# 藥品輸送螺桿問題

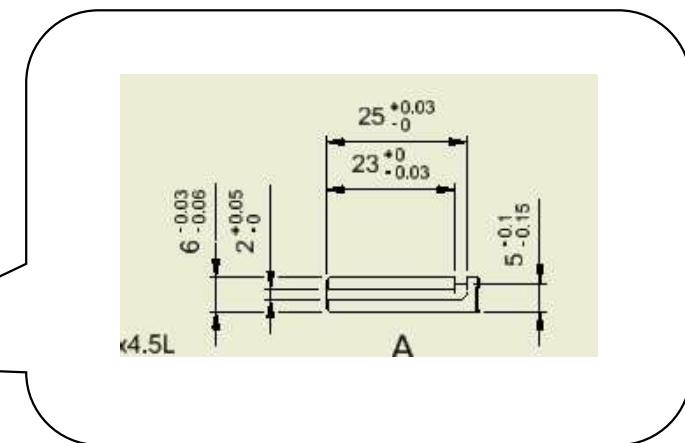
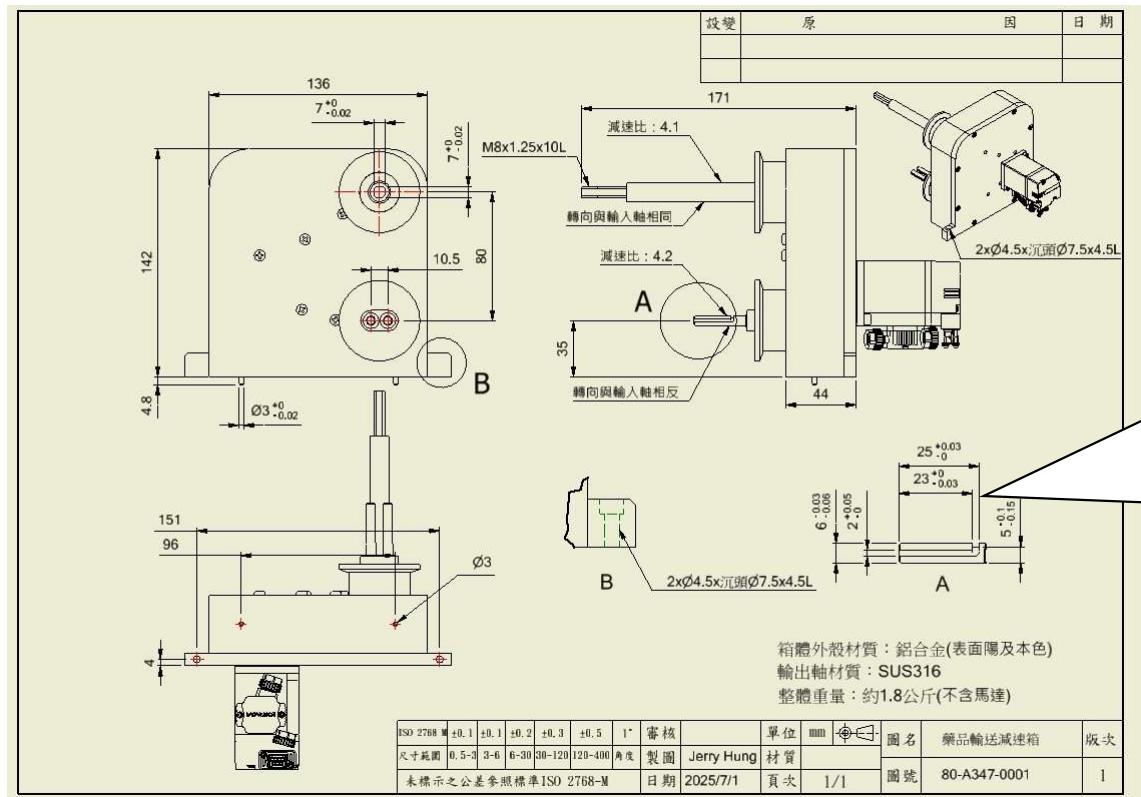
此溝槽套入螺桿內  
凸點卡住無法插入

- 解決方式：實際配合螺桿修改溝槽寬度，不依圖面溝槽尺寸公差處理
